Docket Number:	98-AFC-04C
Project Title:	Sunrise Cogeneration Power Project (Compliance)
TN #:	206822
Document Title:	Sunrise Power Company Petition to Amend for new T1 line
Description:	Petition to Amend (PTA) to install new T1 fiber optic communication line for Sunrise Power Company, LLC
Filer:	Eric Veerkamp
Organization:	California Energy Commission
Submitter Role:	Commission Staff
Submission Date:	12/3/2015 8:49:12 AM
Docketed Date:	12/3/2015

RE: PETITION TO REPLACE - T1 COMMUNICATION LINE
Sunrise Power Company, Fellows, CA
Docket No. 98-AFC-04C

Figure 1 – Project Layout

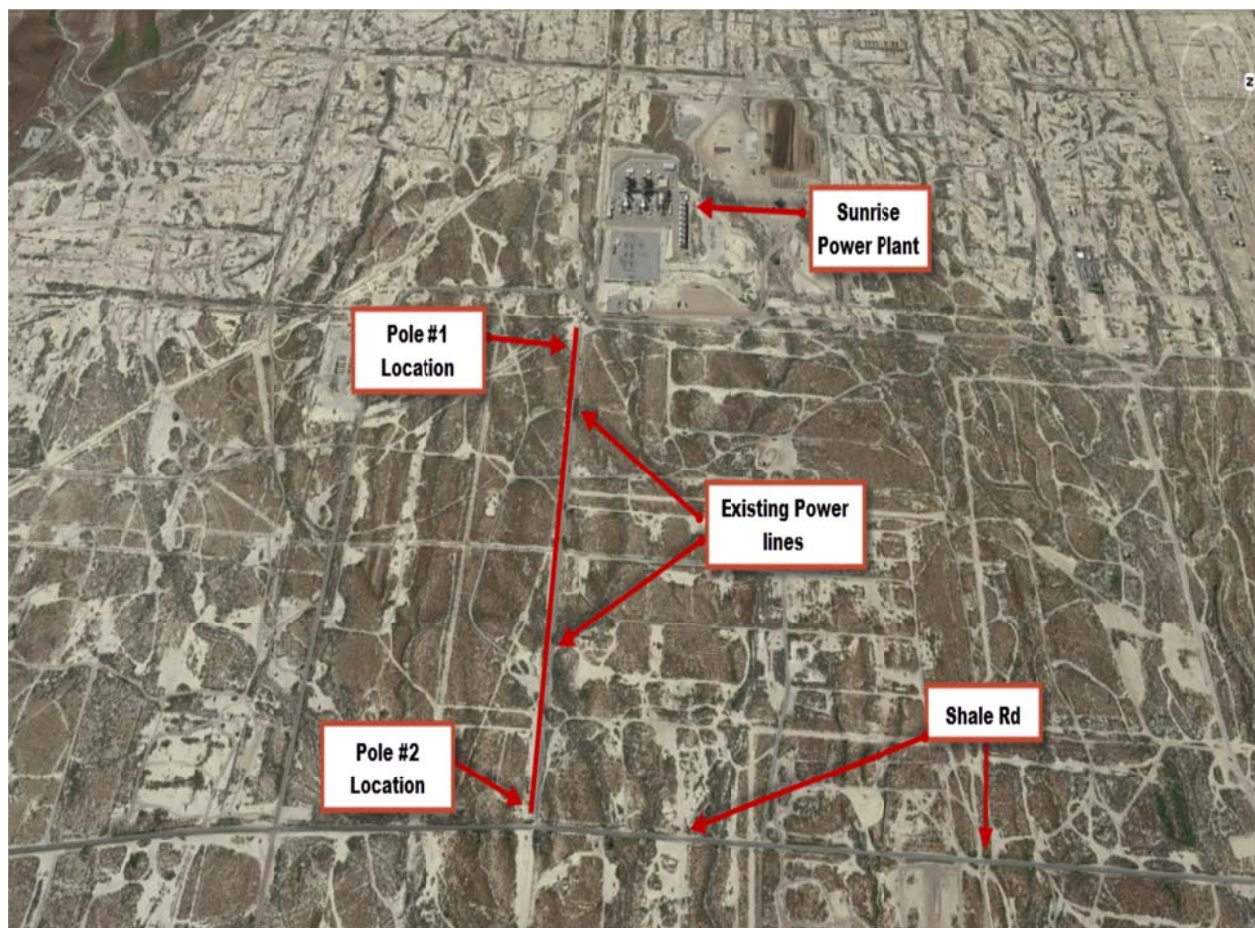
Sunrise has contracted Contra Costa Electric (CCE) to install approximately ½-mile of Verizon fiber-optic cable from Shale Road to Sunrise Power Company on Sunrise Road (see Figure 1 below and Exhibit 1 – figures and photographs depicting current conditions and the proposed alignment of fiber-optic cable along Aera poles. The work will include the following tasks:

- Furnish and install 24SM ADSS fiber-optic cable from Sunrise to Shale Road; cable installation will take place from the service road within the existing easement that includes Sunrise's natural gas, water and wastewater utilities (Exhibit 1). The cable will be installed by CCE personnel utilizing a "cherry picker" lift from the existing dirt service road, as shown in Exhibit 2 photographs.

- Furnish and install (2) 35-foot Class 4 wooden poles rated at 2400 pounds each, fiber-optic cable supports and FOPP; one pole will aid in the transition to the Aera poles and the second pole will reduce the span length between two existing poles to better support the fiber-optic cable. The poles will be set into augured holes several feet deep. Soils removed from the augured holes will be retained onsite within the utility and distributed on the adjoining land.

- Install (5) down guys (i.e., fiber optic connections) to five respective Aera poles.
- Install all tangent and dead-end supports for the ADSS fiber-optic cable.

- Adjust 480 volt power conduit at one location to enable fiber-optic line clearance.
- Terminate, label and test fiber and provide test results to Sunrise.

- Disconnect the Chevron communications line feed into the plant near the administration building (Exhibit 1).
